# **Monitoring Report MY02**

**Stony Fork Restoration Site  
Upper Neuse River Basin - 03020201  
Monitoring Year 02  
DMS Contract 6830**

## MEMORANDUM

Date: February 24, 2021  
To: Lindsay Crocker, DMS Project Manager  
From: Tim Morris, Project Manager  
KCI Associates of North Carolina, PA  
Subject: MY-02 Monitoring Report Comments  
Stony Fork DMS #6830, Contract 006830  
Neuse River Basin CU 030202018  
Johnston County, North Carolina

**SHEET 3 of 4**  
 Source: Google Earth, 2018

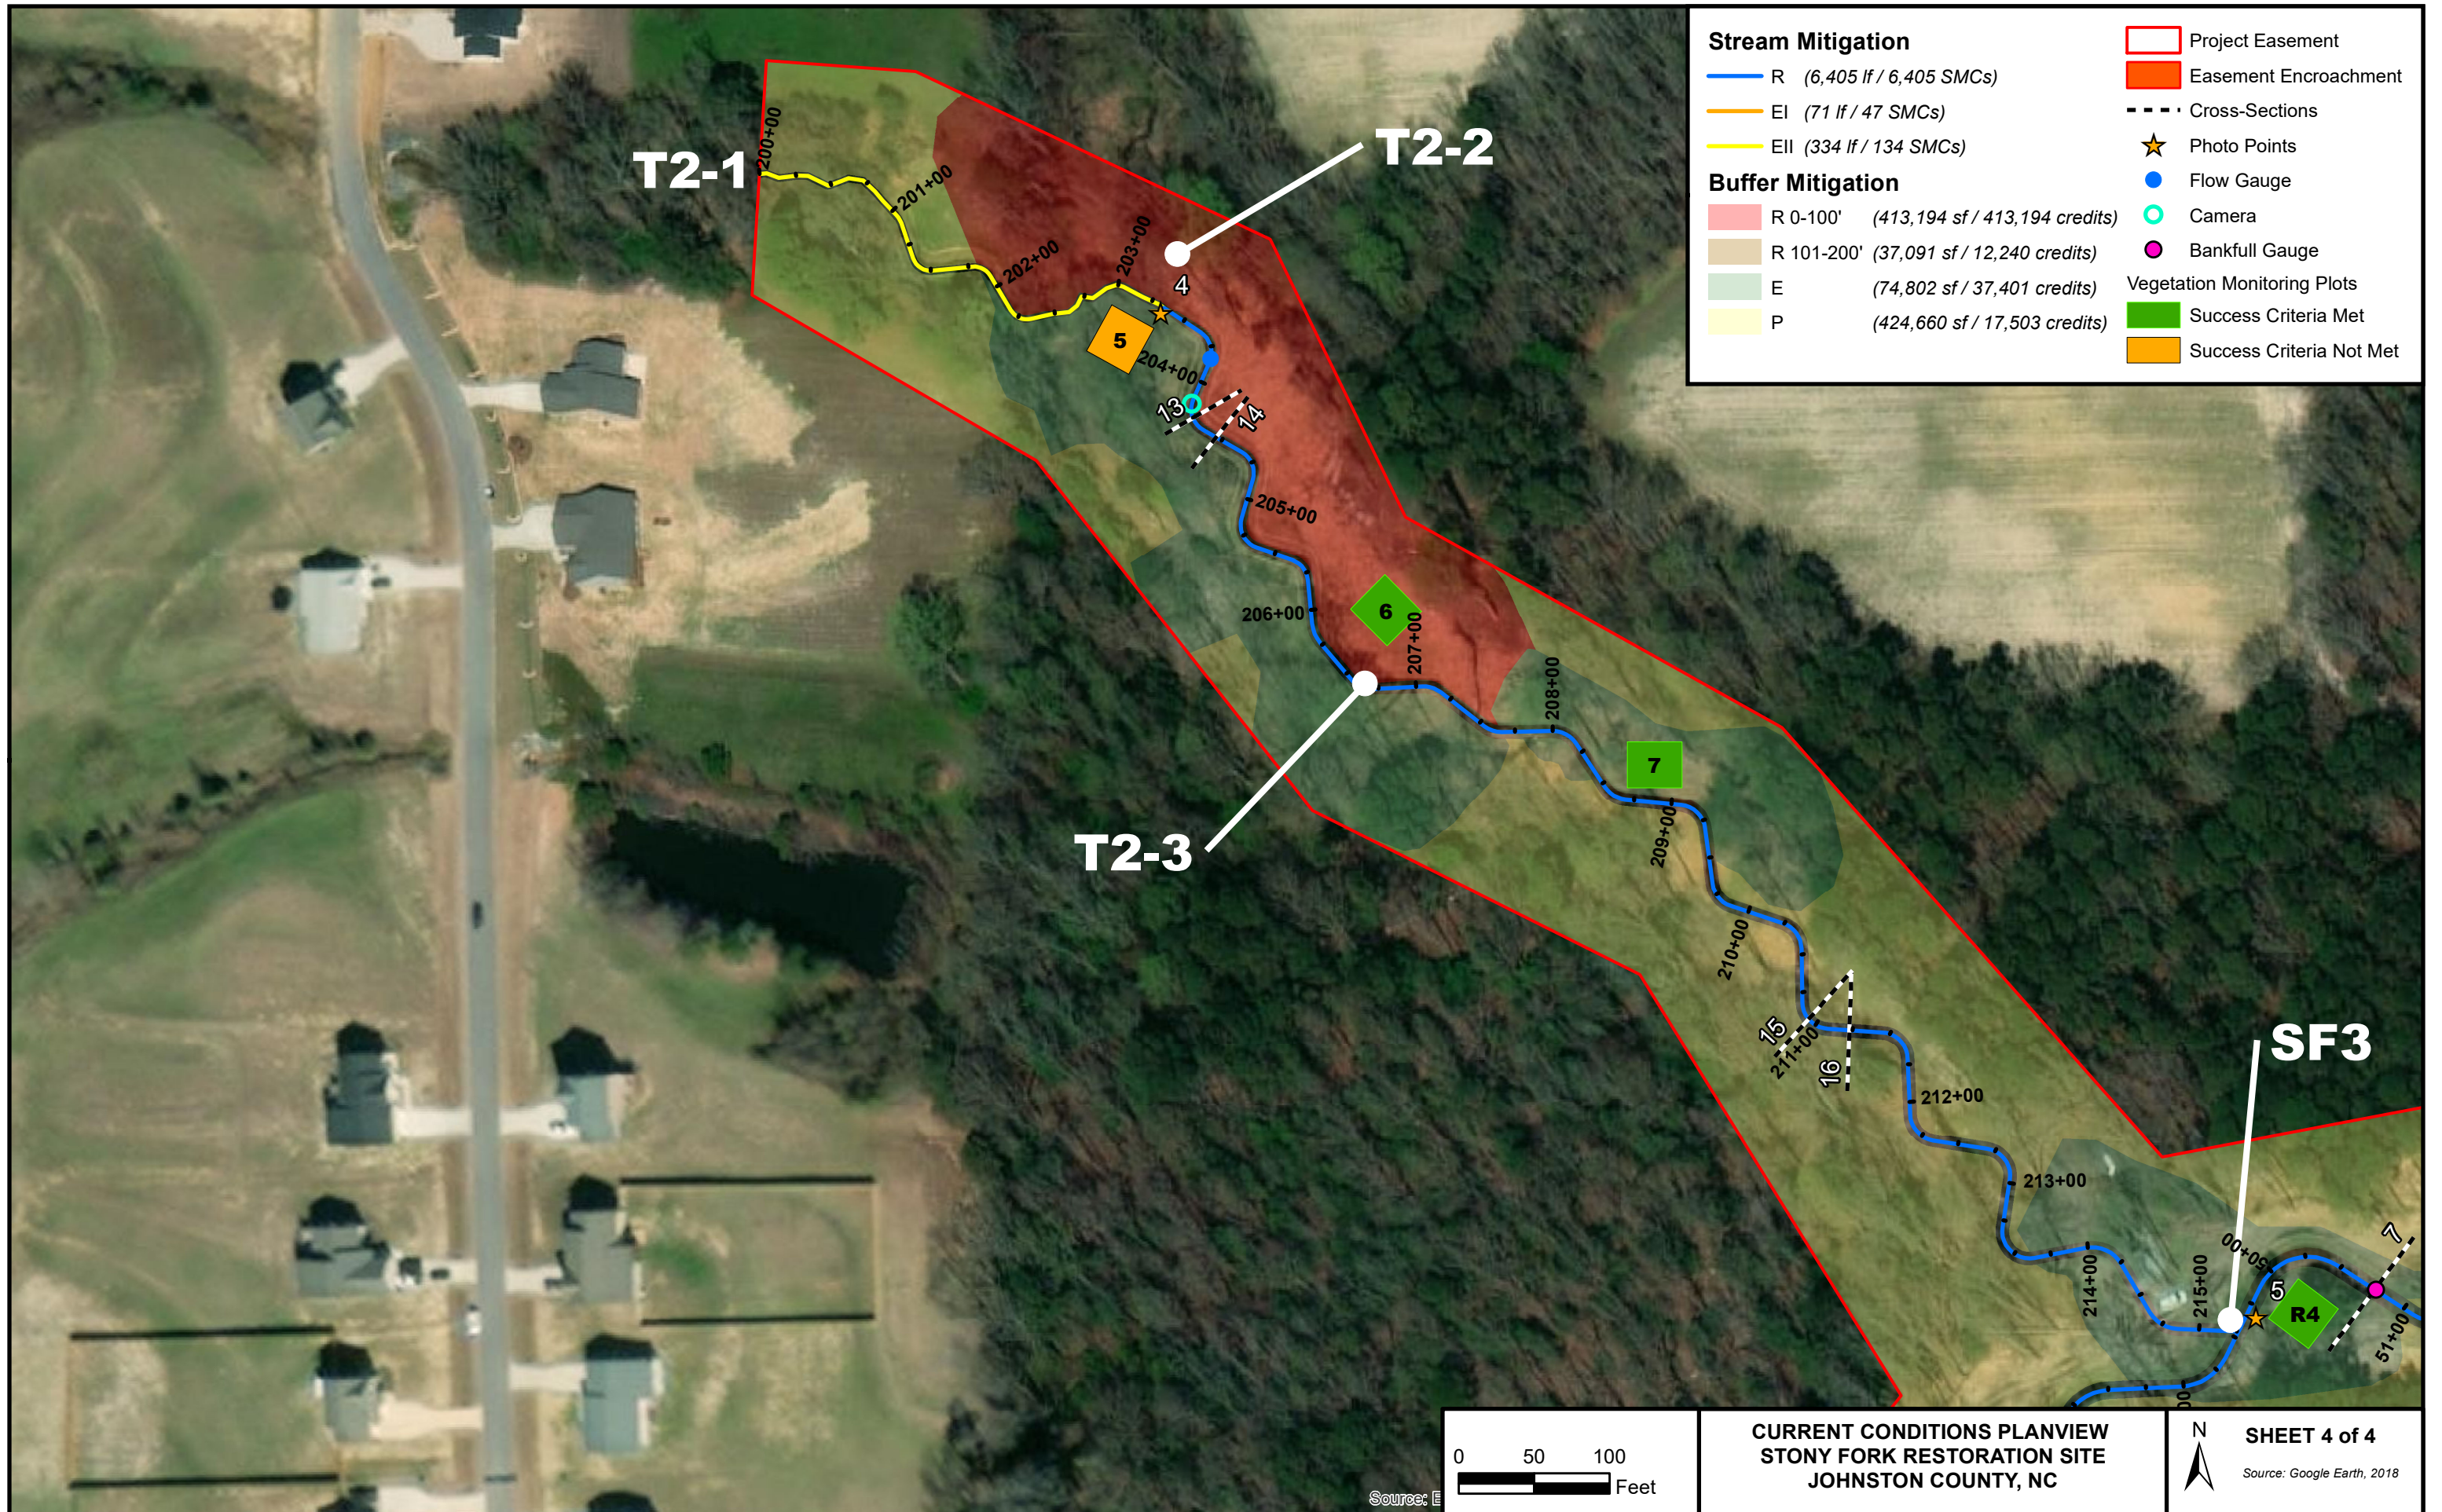
2. Please also document the extent of the encroachment on the CCPV map and measure the area to be reported on the visual assessment table 6 (#5 Easement Encroachment Areas).  
*KCI Response: The extent of the ATV encroachment was surveyed with a handheld GPS on February 9, 2021 and the CCPV and visual assessment table have been updated to show the encroachment.*
